# PRODUCT RECALL ACTION NOTICE

PR 06-02

**Subject:** YCAV Chiller Feed and Drain Valve Component Failures

Figure 1: Feed and Drain Valve Example

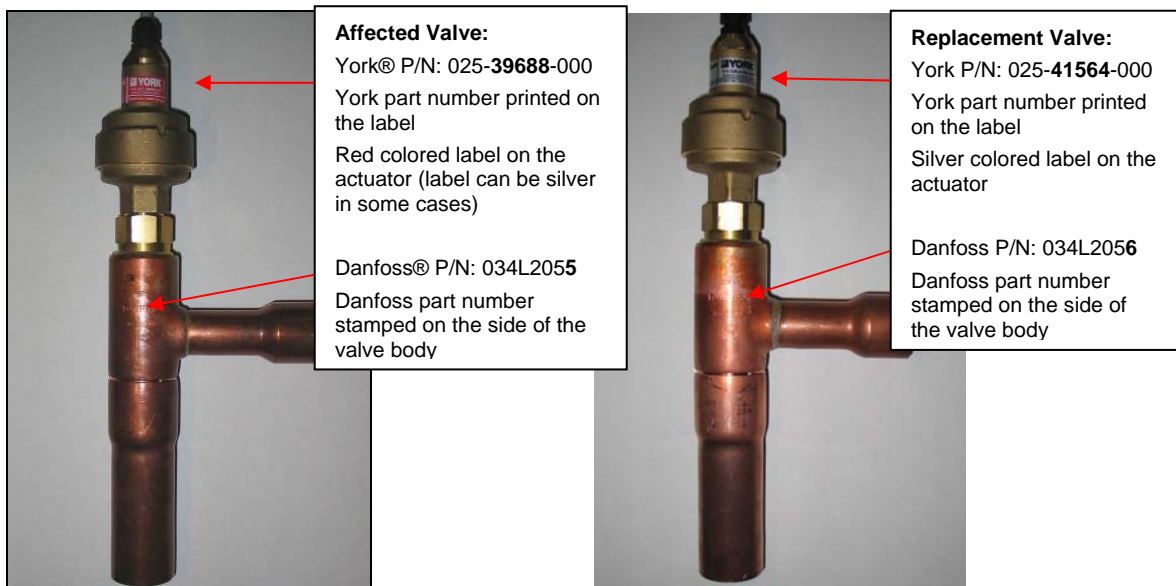
**Problem:** The **025-39688-000 Feed and Drain Valves** used to control the flash tank level and refrigerant flow to the evaporator fail within the first few months of operation causing the affected refrigerant circuit to shut down on a system fault (safety). Various safeties may occur depending on the valve position when it fails. Typical safeties are low suction superheat, low discharge superheat, low suction pressure, and high or low flash tank level.

Figure 1 shows an example of the affected 025-39688-000 valve and its 025-41564-000 replacement valve.

**Note:** Some affected valves have silver labels. Always check the part number on the label.

**Solution:** Order the required **025-41564-000** replacement valves **immediately**, and replace all valves in the chillers shipped prior to May 17, 2006, with the new valves as soon as possible. If some of the valves on the chillers have already been replaced with the new valves, order only what you need to replace the existing affected valves.

**Note:** Externally, both the original and the replacement valves appear virtually identical other than the part number. Use Figure 1 to identify old and new valves as required.
